STATE OF WASHINGTON
NUCLEAR WASTE BOARD

RE: Revised Comments on the Draft EA

NUCLEAR WASTE BOARD
STATE OF WASHINGTON
COMMENTS ON THE DRAFT ENVIRONMENTAL ASSESSMENT

REFERENCE: Technical Review Comment on
DRAFT EA: REFERENCE REPOSITORY LOCATION,
HANFORD SITE, WASHINGTON, December 1984.
SEARCH : 5545

FIGURE 3. TRITIUM HISTORY OF WELL 699-2-3

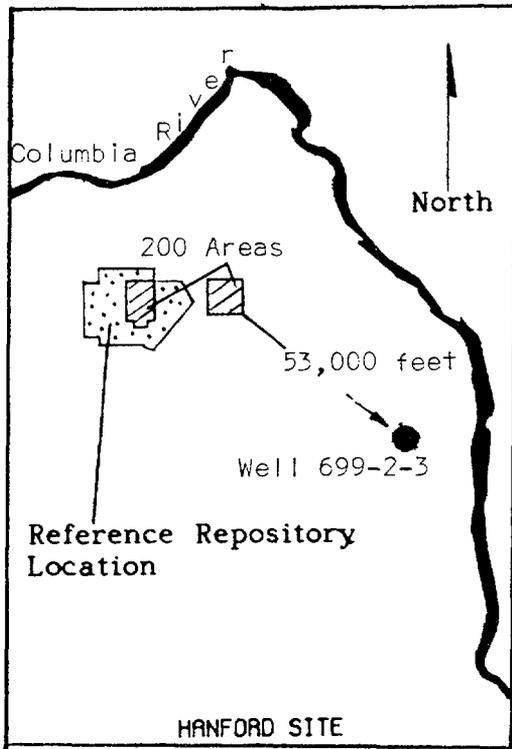
Well 699-2-3 was selected for this travel time estimate because its tritium record is particularly simple: There is an abrupt breakthrough of tritium-bearing water in 1965, followed by an exponential increase in concentration, followed by near attainment of saturation concentration in 1976.

Although the horizontal leg of the surface aquifer, extending from 3,000 feet over the reference repository location to the Columbia River, has a travel time of only 21 years to breakthrough, there is no similarly conductive vertical leg connecting the repository

FIGURE 4.

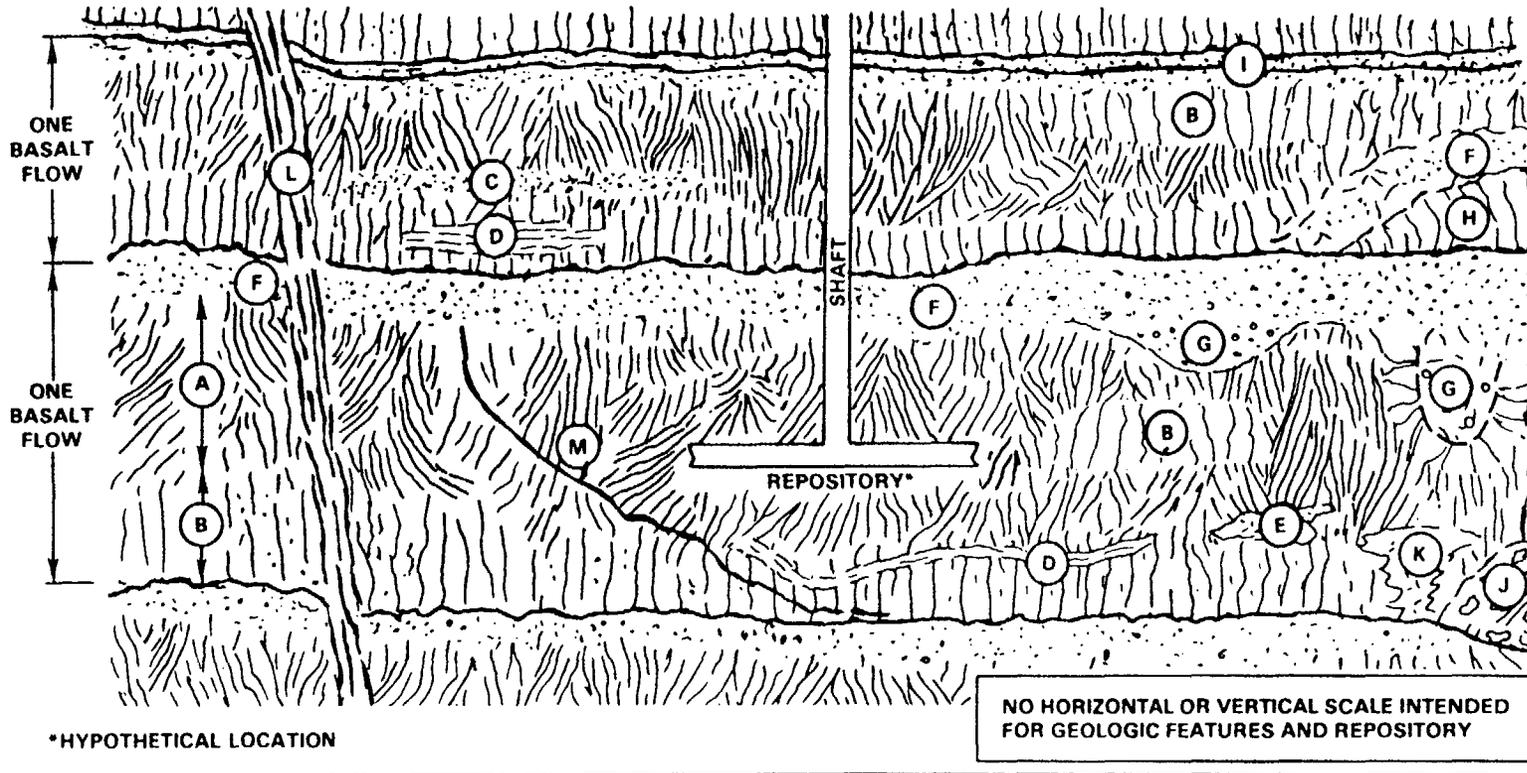
Figure 4, taken from the DEA, provides a hypothetical, composite cross section of possible geologic features in a layered basalt sequence with the repository sketched [4]. This figure shows an interbed situated one basalt flow above the basalt flow in which the repository is located. Furthermore, Fig. 4 shows a major fault or fracture which connects the level of the repository with the level of the interbed. That is, Fig. 4 presents hypothetical vertical and horizontal legs of a pathway which might connect the repository to the Columbia River.

stratigraphy (Fig. 1) may be combined with the hypothetical geologic features of Fig. 4 to allow some appreciation of possible spatial relationships. Figure 5 is the diagrammatic result, with the repository shown in the Cohasset Flow which the DEA finds to be most geologically promising [6].

FIGURE 5.

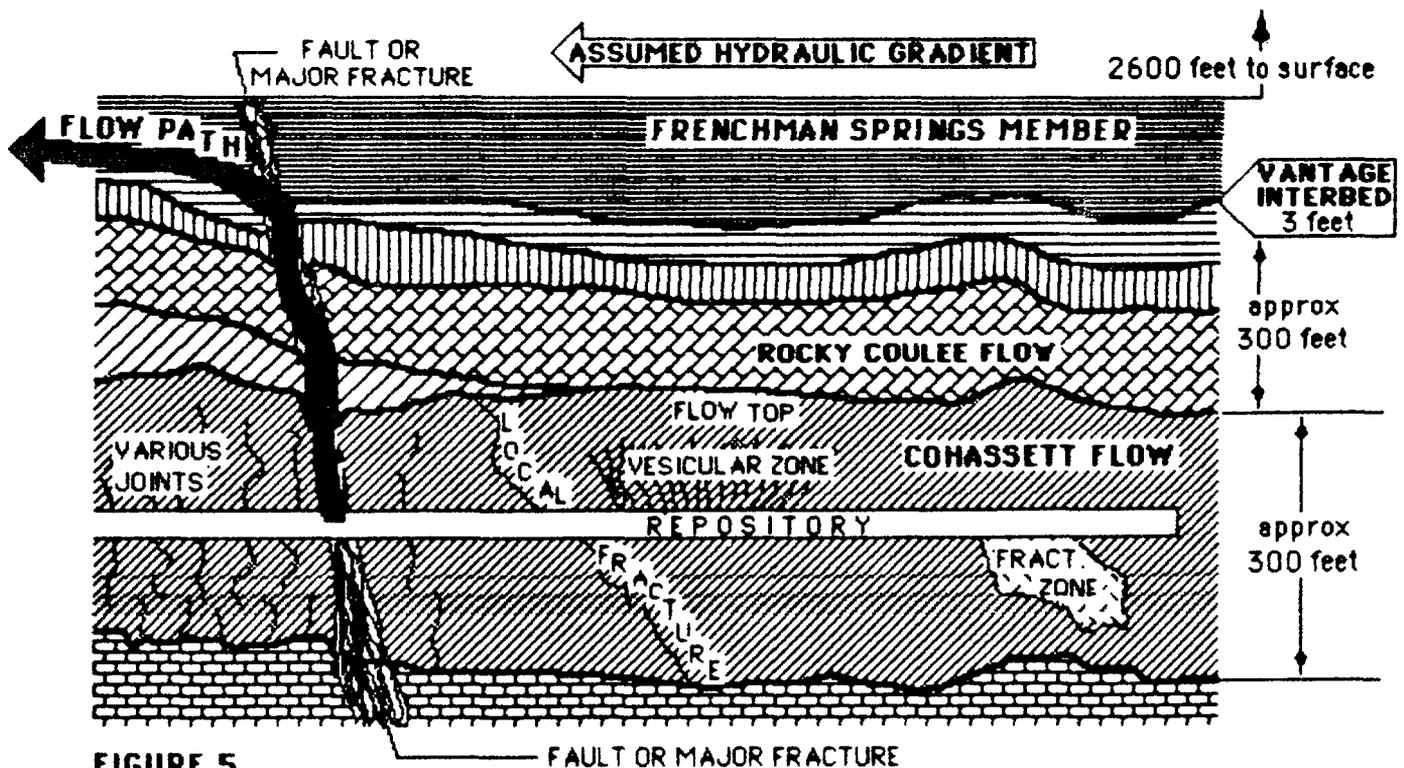
Figure 5 shows this scaled repository to cross several vertical discontinuities in the Cohasset Flow. The most severe of these discontinuities, a fault or major fracture, is shown as connecting the repository to the Vantage Interbed, some 400 feet above it.

FIGURE 9 - Sensitivity of Groundwater Travel Times To Variations in Effective Thickness and Regional Hydraulic Gradient

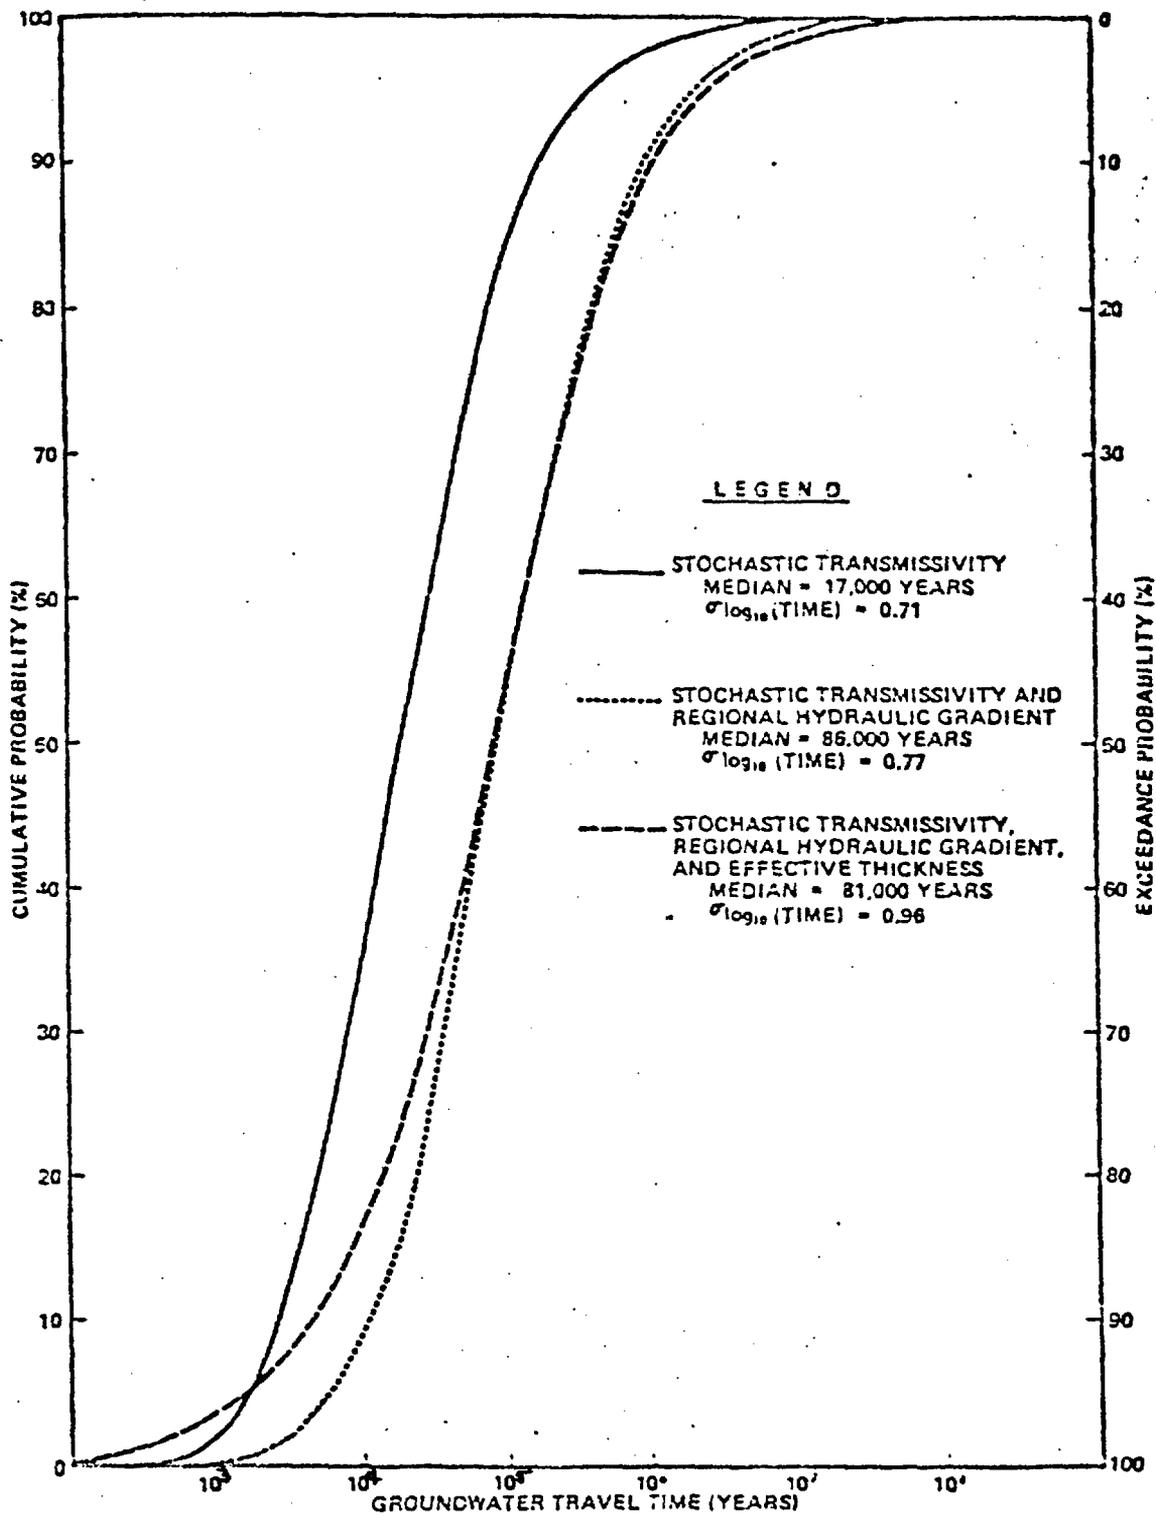
$\text{Pr}(\text{travel time} < 1000) = F((\log(1000) - \log(M))/s)$. The table below compares these estimates with the probability estimates directly from the empirical c.d.f. (Figure 9 in SD-BWI-TA-013, which greatly enhances the comparison; see Fig. 6-22 in the DEA). If the model (iii) has the highest median groundwater travel time, it also has the highest risk of a short travel time. This appears to be a consequence of the extra random variation.

(iii) 81,000 0.96 -1.988 0.0234 0.036* z =
 {log(1000 years) - log(M)}/s. Figure 9 is attached. One can also read off
 P(10,000 years) from the three models as, respectively, 0.42, 0.10, and 0.17.
 These probabilities appear not low, by usual risk assessment criteria, in spite
 of the long median travel times.

FIGURE 27. Distribution of Groundwater Travel Times from Models with Different Log-Transmissivity Correlation Ranges.

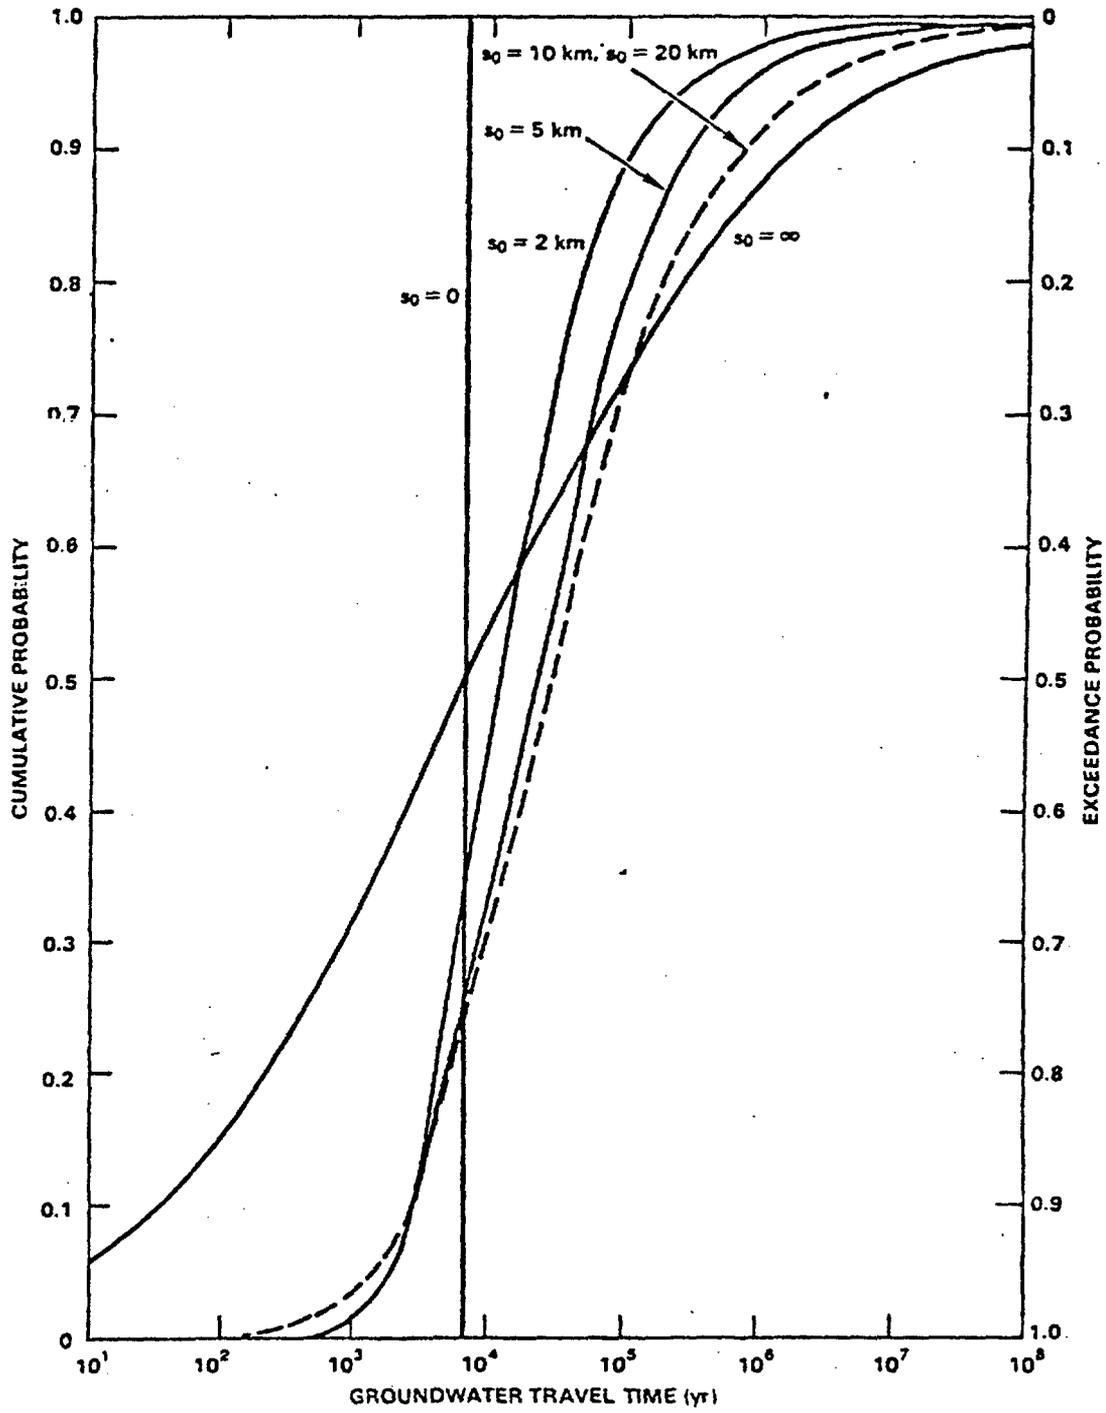
See Figure 27 attached. The "eyeball" estimate of $\Pr(\text{t.t.} < 1000 \text{ years})$ can be read as about 0.015 for a 2 km correlation range, about 0.03 for 10 km correlation range, and 0.30 for an extremely long correlation range. Since the correlation range is not actually known (even within the context of a spatially isotropic model), the risk implications can vary over an uncomfortably large range. Note how much more informative are the actual probabilities. Since they have already been calculated, they should be reported.

FIGURE 29. Distribution of Groundwater Travel Times from Models with Different Cross Correlations between Transmissivity and Effective Thickness.

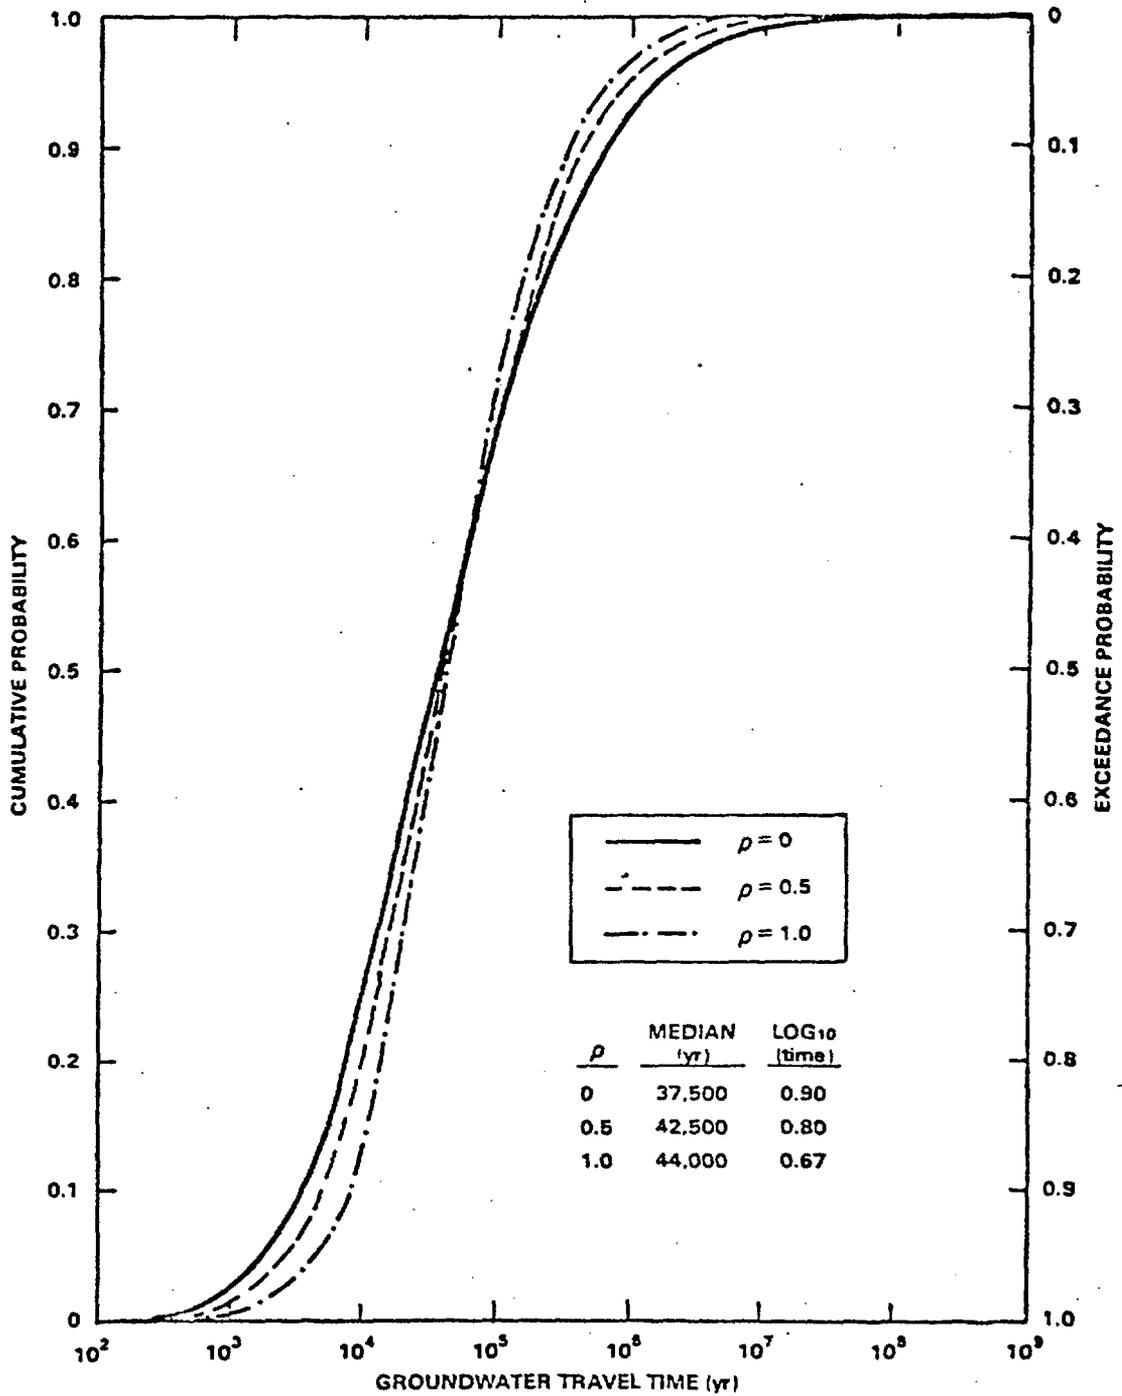
See Figure 29 attached. When effective thickness is assumed log-normal and correlated with log-transmissivity, both median and log std. dev. of t.t. are affected, but the effect on $\Pr(\text{t.t.} < 1000)$ is much larger. Furthermore (p. 61) "If a symmetric probability distribution, such as normal, was used [for effective thickness] in this analysis, the median travel times would be less than the travel times calculated in this section."
